RECOMMENDATION MEETING

2203 23rd Avenue S
Seattle, WA 98144

3034558-LU

8.0 ITEMIZED RESPONSE TO EDG 2

FIGURE 1

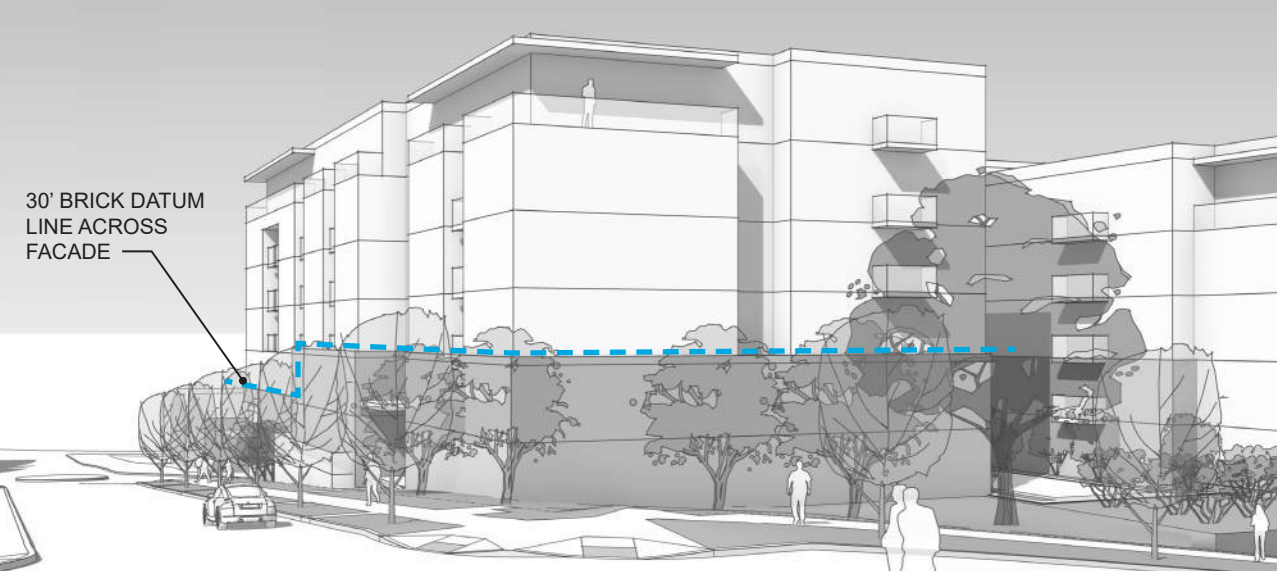
The Board discussed the response to previous guidance to address the impacts of height, bulk and scale at the transition to single family zoning along the south and west property lines. The Board agreed that the façade modulation, balconies, 30’ datum line, upper level setbacks, and other secondary architectural elements proposed in the applicant’s preferred massing option are sufficient to mitigate the bulk and scale of the proposal at the zone transition. These elements should remain as the project is further developed. (DC2.A.2, DC2.C.1, CS2.D.3)

Refer to Figure 1. The building’s datum lines to the west and south have been retained per the Board’s comments.

FIGURE 2

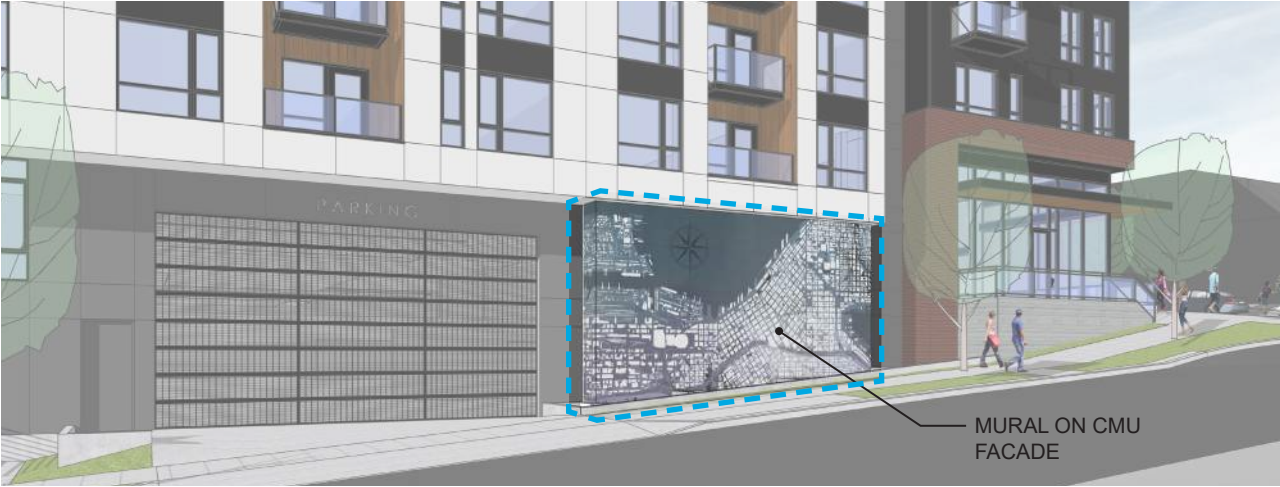
The Board also noted the mural on the existing structure and recommended incorporating this mural art and other elements that reflect the cultural character of the neighborhood or existing structure in the proposal. The Board is supportive of using mural art to mitigate blank wall areas and open to considering departure requests that might be required to do so. (CS3.B, DC2.B.2)

See Figure 2. A mural wall is proposed along S Walker Street in front of the building’s trash room and adjacent to corner retail to the west. The final mural design will be developed as the project develops, but a large graphic is expected to envelop the proposed wall. Shielded uplighting is also proposed to highlight the final mural design. Refer to page 62-63 for more information.

FIGURE 4

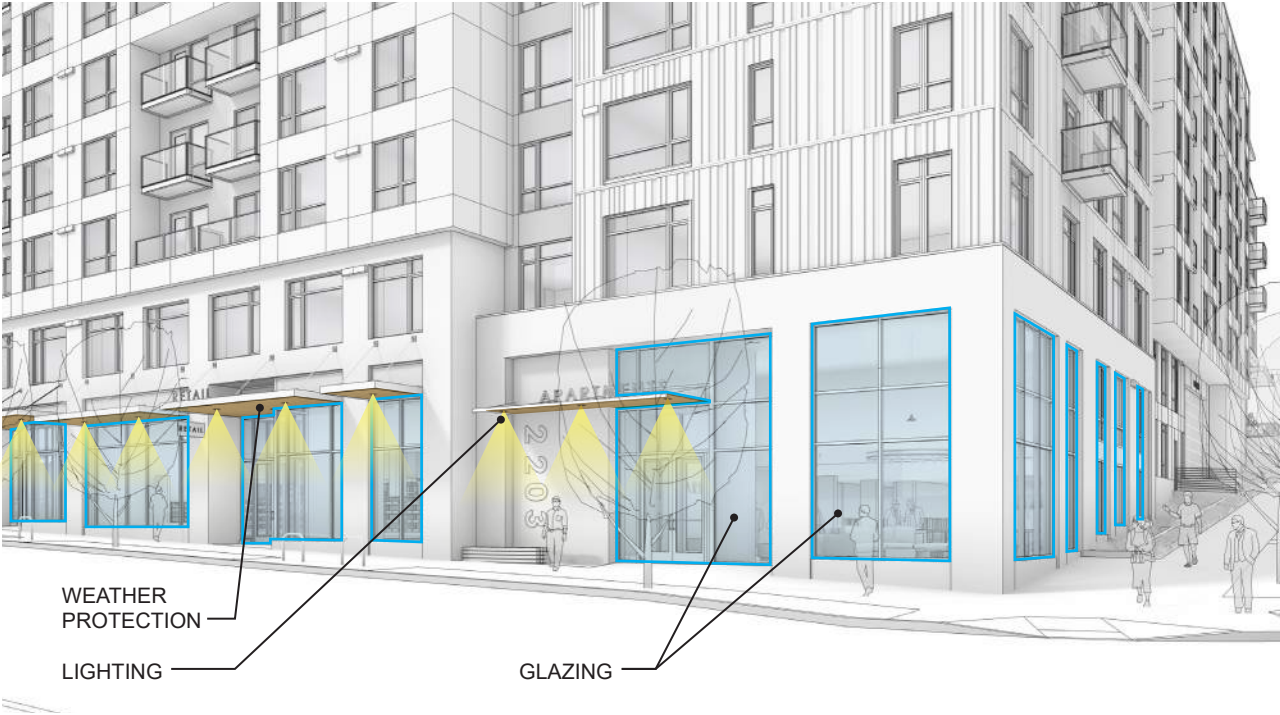
The Board provided guidance to treat the residential entry with care, including consideration of transparency, lighting, and signage. (PL3.A)

See Figure 4. Ample transparency is provided along 23rd Avenue S to provide views into the building’s lobby and retail spaces. Solid overhead canopies with lighting are proposed along the street to enhance the pedestrian experience and illuminate the sidewalk at night. Signage above the canopies are proposed for both the northeast lobby entrance as well as all retail entrances. Blade signage is also proposed along the sidewalk for retail entries on 23rd Avenue S to aid in pedestrian visibility. Refer to signage concept sheets for more information.

FIGURE 5

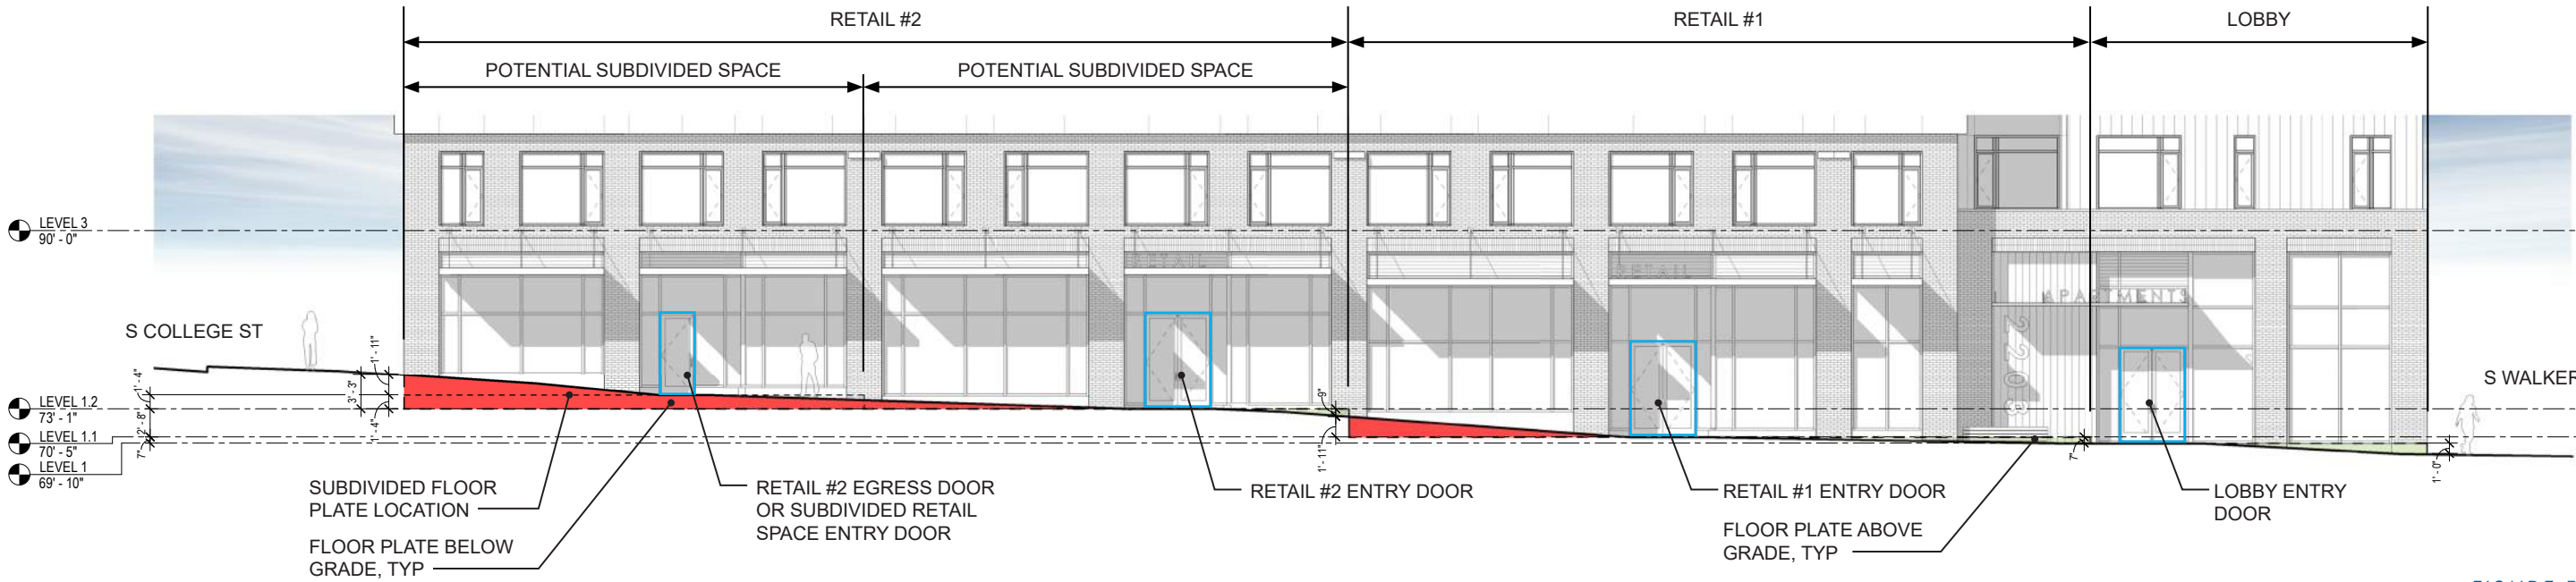
The Board was concerned with the sunken condition of the retail space and provided guidance to better relate the retail spaces to sidewalk grade. This could include providing level outdoor seating areas and carefully studying where steps in the slab occur. (PL3.C), CS1.C)

The Board also encouraged the applicant to be flexible in the design of the retail space to allow potential future division into smaller spaces. (DC1.A.3, PL3.C)

See Figure 5. The design team studied locating retail doors along 23rd Avenue S to best optimize the spaces’ floor plate locations. It was determined that due to pedestrian traffic predominantly coming from the northeast corner of the site, locating retail entries on the north side of their respective commercial spaces would be advantageous for increasing traffic. This is especially true for Retail #2 which sits the furthest from the northeast corner. Consequently, this means that each retail floor plate sinks slightly into the hillside south of their entry doors. Since EDG2, the entry door for Retail #1 has moved south to help mitigate this issue, but it was determined that the benefits of retaining an entry door to the north outweighs the detriments of sinking the floor plate into the hillside. Furthermore, the lower slab condition allows for a lower concrete knee wall than a higher floorplate that is predominantly higher than grade.

See Figure 5. An additional floor plate location has been integrated into the proposed design so that the existing egress door shown in Retail #2 could serve as the subdivided retail space’s primary entry. This also raises the finish floor elevation for the new retails space 16” higher than Retail #2 which will help mitigate below grade issues discussed in Comment 4.C.
